## ADDENDUM NO. 2 TO PROJECT NO. 148170, C4 Riverwest Phase III & IV Neighborhoods Initiative

## ADDENDUM NO. 2 TO RIVER WEST PHASE CNI PHASE III & IV PROJECT NO. 148170 C4 & TMUA-W 19-10 P2 & ES 2019-11

### JUNCTION BOX TYPICAL DETAILS

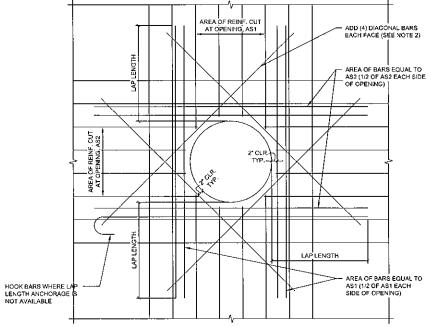
- 11. Plan Sheet 35b: Sheet added for typical details of 7'x9' cast-in-place concrete junction box with 5' diameter riser.
- 12. Plan Sheet 36: Storm sewer replacement extended to the manhole located at the center of 23<sup>rd</sup> Street. The existing manhole in the center of 23<sup>rd</sup> renamed to "1A" and Structure 1 renamed "1B". Structure 1A and 1B shall be replaced with a 7'x9' junction box with riser. The existing 27" storm sewer between structures 1A and 1B replaced with 43"x68" Elliptical RCP. Replacement of sidewalk, curb, paving and concrete median reflected along 23<sup>rd</sup> Street to account for the additional storm sewer replacement. Inlet "e" changed to a CICI Design 4 inlet.
